Product Change Notification / ASER-06FDTY754

CCB 4882 Initial Notice: Qualification of a new molding compound for selected LR8Nxxx, LR645Nxxx, LR745Nxxx, LR12Nxxx, HV992xxx and TC32Mxxx device families available in 3L TO-92 package at CRTK assembly site.

CCB 4882
Pre and Post Change Summary
PCN #: ASER-06FDTY754

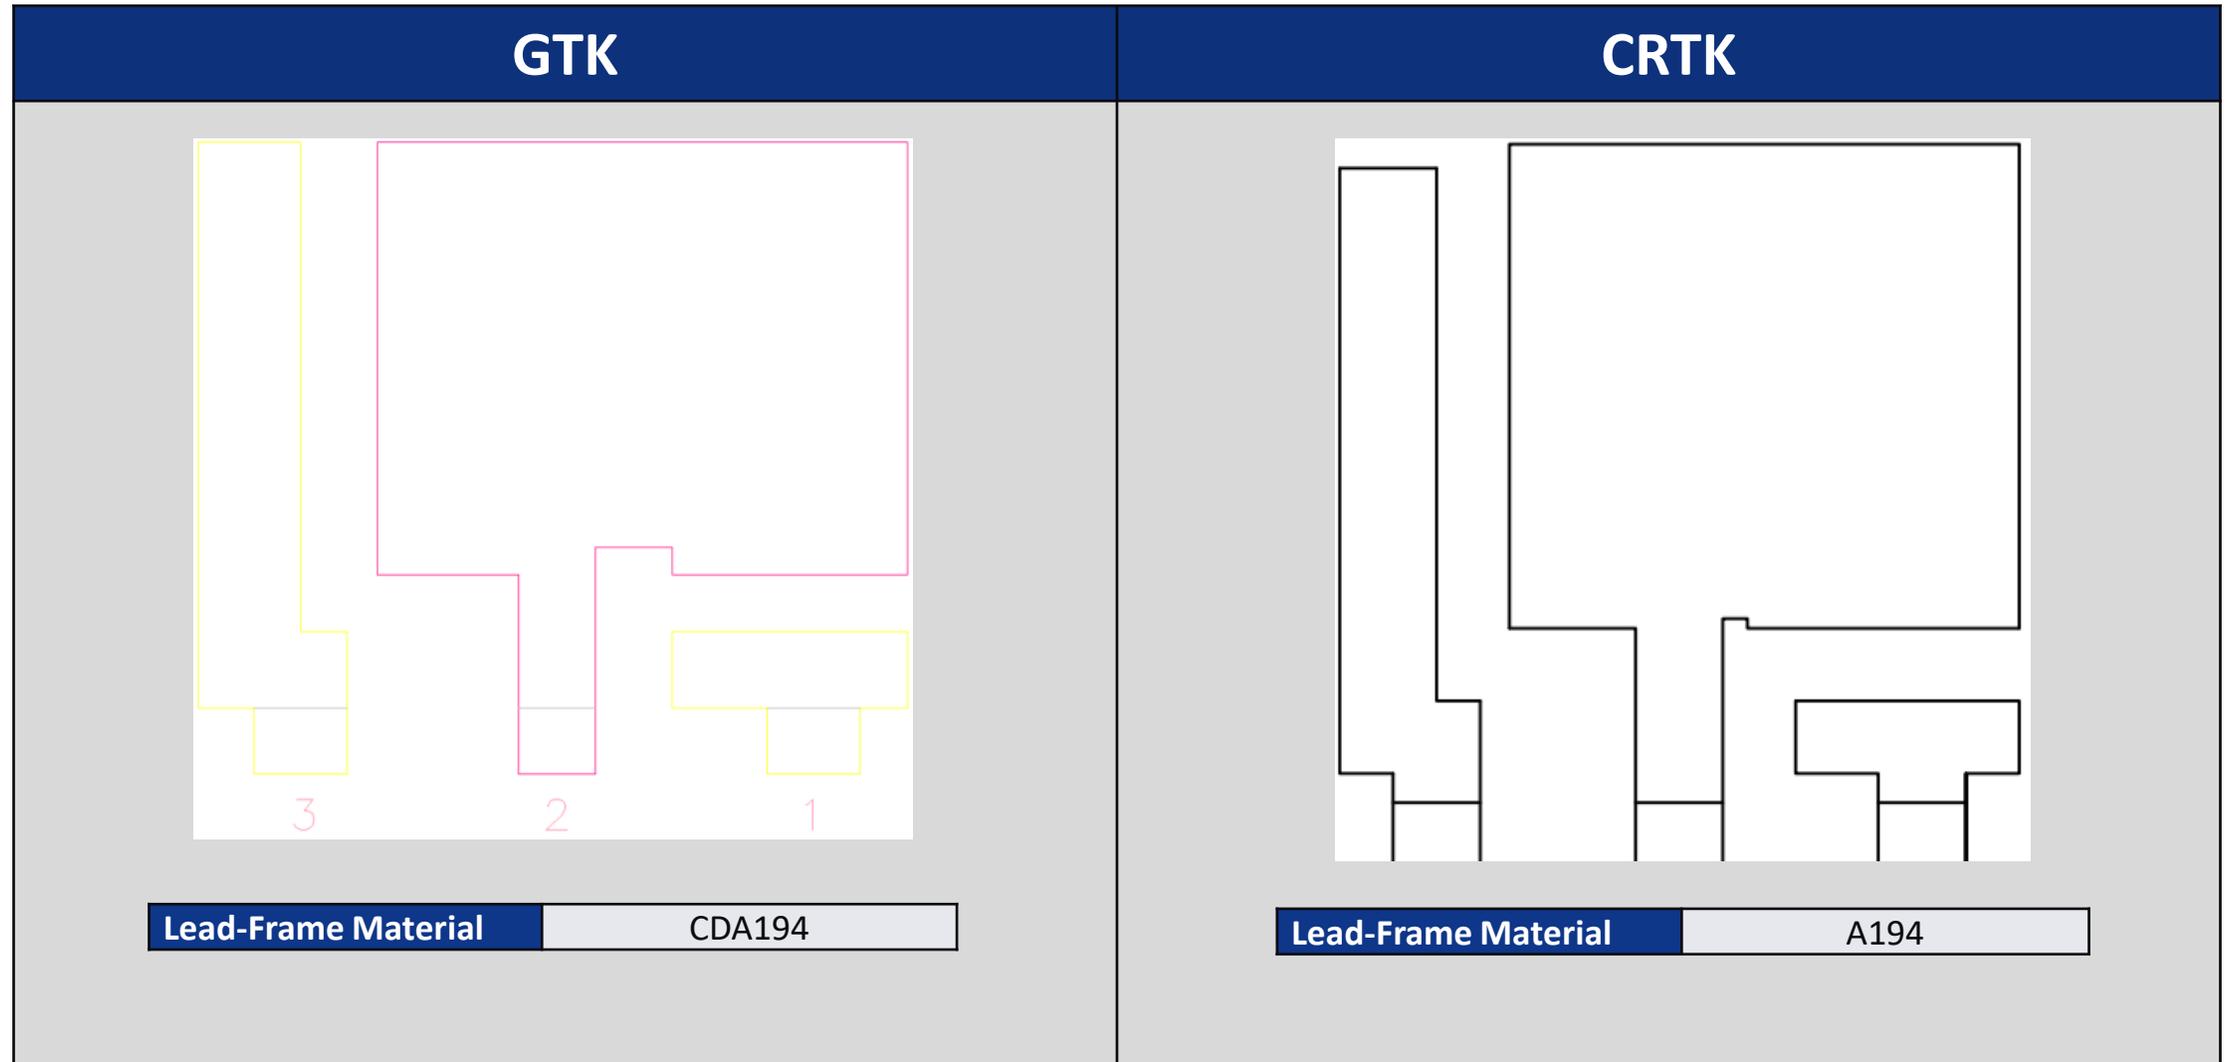
Description of Change:Qualification of a new molding compound for selected LR8Nxxx, LR645Nxxx, LR745Nxxx, LR12Nxxx, HV992xxx and TC32Mxxx device families available in 3L TO-92 package.

Pre Change		Post Change
Assembly Site	GREATEK ELETRONIC INC. (GTK)	Cirtek Electronics Corporation (CRTK)	Cirtek Electronics Corporation (CRTK)
Wire Material	Au	Au	Au
Die Attach Material	CRM1076DJ-G	84-1LMISR4	84-1LMISR4
Molding Compound Material	G600F	EME-G600	CEL-8240 GS
Lead-Frame Material*	CDA194	A194	A194
	See Pre and Post Change Summary for Comparison.

*Note: C194, A194 or CDA194 Lead frame material are the same material, these are simply a MCHP internal labelling difference.
